# Access Compliance Report

## Public Rights-of-Way

### (Curb Ramps)

Intersection ID: 18792	Main Street: BARCLAY_DOWNS_DR	Cross Street: SAGAMORE_RD	Location:	N
ADA ID: 002C09F59E95	Ramp Type: PerpDiag	Initial Pass/Fail: Fail	Overall Compliance: No	Severity Score: 25

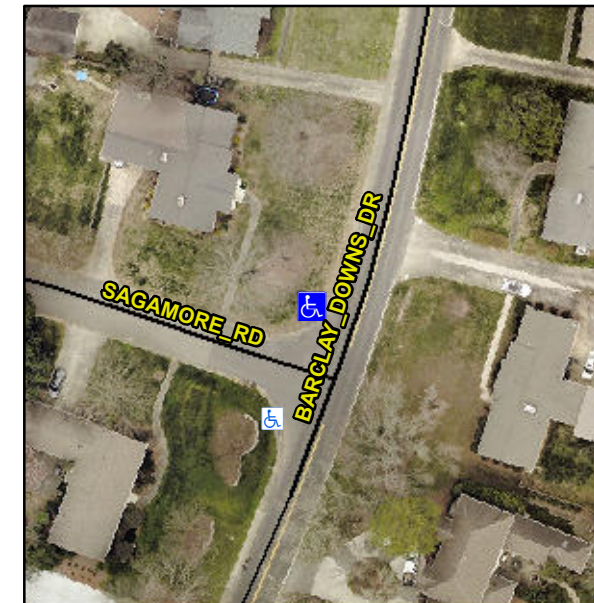
**R304.2.2**

Compliance	Description	Data	Compliance	Description	Data
N/A	Ramp Length (in)	38.0	No	Ramp Slope (%)	15.1
Yes	Ramp Width (in)	48.0	Yes	Ramp XSlope (%)	0.5
N/A	Flare Type LT	N/A	N/A	Flare Type RT	N/A
N/A	Flare Slope LT (%)	N/A	N/A	Flare Slope RT (%)	N/A
N/A	Flare Traversable LT?	N/A	N/A	Flare Traversable RT?	N/A
N/A	Landing Length (in)	N/A	N/A	DWS Provided?	N/A
N/A	Landing Width (in)	N/A	N/A	DWS Contrast?	N/A
N/A	Landing Slope (%)	N/A	N/A	DWS Length (in)	N/A
N/A	Landing X Slope (%)	N/A	N/A	DWS Full Width?	N/A
N/A	Landing Curb? (Y/N)	N/A	N/A	DWS Offset (in)	N/A
N/A	Shared Landing?	N/A			
N/A	Gutter Ponding?	N/A	N/A	Gutter Slope (%)	N/A
N/A	Gutter Lip Ht (in)	N/A	N/A	Gutter X Slope (%)	N/A
N/A	Painted X Walk1?	No	N/A	Painted X Walk2?	No
	X Walk 1 Direction	To SW		X Walk 2 Direction	To SE
N/A	X Walk 1 Width (in)	N/A	N/A	X Walk 2 Width (in)	N/A
	X Walk 1 Slope (%)	0.5		X Walk 2 Slope (%)	2.2
	X Walk 1 X Slope (%)	1.6		X Walk 2 X Slope (%)	0.2

**Remove & Replace Curb Ramp With Two New Directional Ramps or Equivalent.**
